Urbicus Ref: URB25-154
Primary Contact: Mark Clayton

Applicant response to Further Advice

Council reference: A006913284
Property details: 30 Hertford Street, Upper Mount Gravatt QLD 4122

Figure 1 – Podium Screening Details.

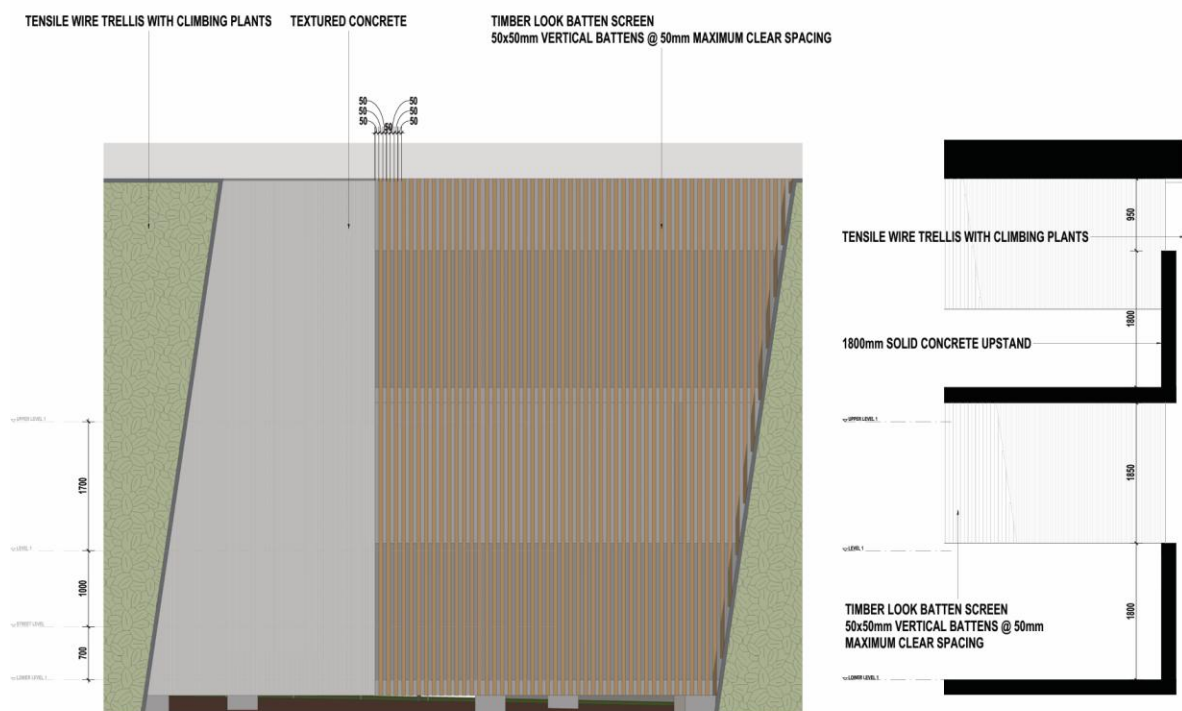
Item	Above Ground Parking Impacts
1	<p>The overall bulk, scale, and extent of the above-ground parking levels present as visually dominant to adjoining properties. While some variation is proposed to the perimeter treatment, this does not meaningfully reduce the apparent massing of the podium and does not achieve PO8, PO9 and PO34 of the Multiple dwelling code. Accordingly:</p> <p>a) Submit amended plans to demonstrate screening to above ground parking areas to allow for greater visual variation in the façade treatment and provide for visual depth. This may include integrated planting outcomes; however, any such</p>

treatment must be demonstrated as an integral component of the design and supported by appropriate planter dimensions, irrigation, and maintenance details.
--	---

Item	
2	<p>The proposed 1.8m upstands and batten screening to the perimeter of above-ground parking levels are noted. However, the elevations and sections are not suitably detailed to demonstrate the degree of transparency and visual permeability that is achieved. To demonstrate an above-ground parking outcome in accordance with AO34.1/PO34 and AO35.2/PO35 of the Multiple dwelling code:</p> <ul style="list-style-type: none"> a) Provide details demonstrating that batten screening is designed with maximum spacings not exceeding 50mm to limit views into the podium parking areas and mitigate visual amenity impacts to surrounding properties. b) Confirm that the 1.8m upstands are rated to function as effective acoustic barriers in addition to assisting with visual screening. c) Provide updated elevations and sectional drawings of the typical podium screening details, clearly identifying batten spacing and the size of batten screening elements.

Vertical landscaping has been integrated into the podium design in addition to textured concrete walls and batten screens with a maximum spacing of 50mm. Refer to Figure 1.

Refer to Architectural Plans and Figure 1.

We confirm that the 1.8m upstands are rated to function as effective acoustic barriers.
